**PRELIMINARY DRAINAGE REPORT  
FOR  
TIMBERRIDGE ESTATES, PRELIMINARY PLAN  
PART OF THE RETREAT AT TIMBERRIDGE  
(NORTH OF ARROYA LANE)**

**October 2018**

TNE Job No. 1733.00  
County Job No. SP-18-002

Project: **Timber Rider Estates** Location: **Point EX1 - Min 100 Yr Channel Size (Q=1.2 cfs)**  
 By: **Dane Frank** Date: **5/31/2018**  
 Chk By: \_\_\_\_\_ Date: \_\_\_\_\_ version 12-2004

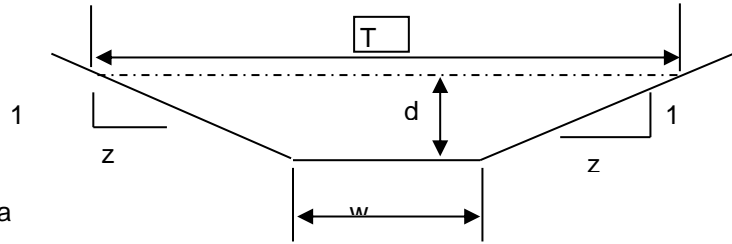
Label the proposed easement widths, here, on each sheet, for each section EX1 through EX 11.

Basin ID: **Arroya Lane Crossing Sand Creek (2,607 cfs) - 3-6'x12' Conc Box Culverts**

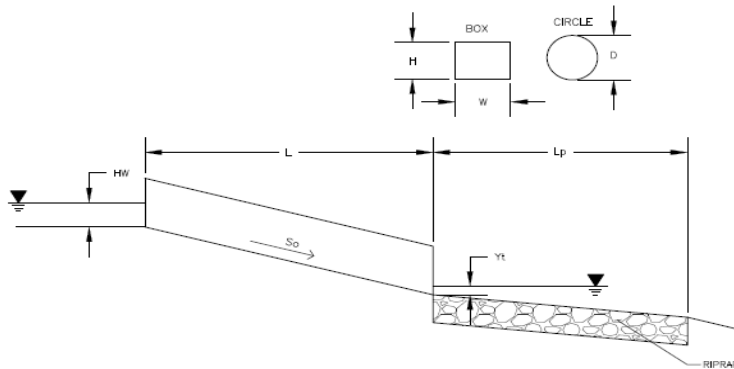
See note at bottom of calculation sheet. Freeboard is entering the culvert, not internal. Discuss size required to meet the 2-foot criteria and if a deviation might be requested at the final plat stage.

The south report provided an analysis of 3-6x16 RCBCs. Discuss options, including what size would be required to meet the 2-foot freeboard requirement (entering the culvert).
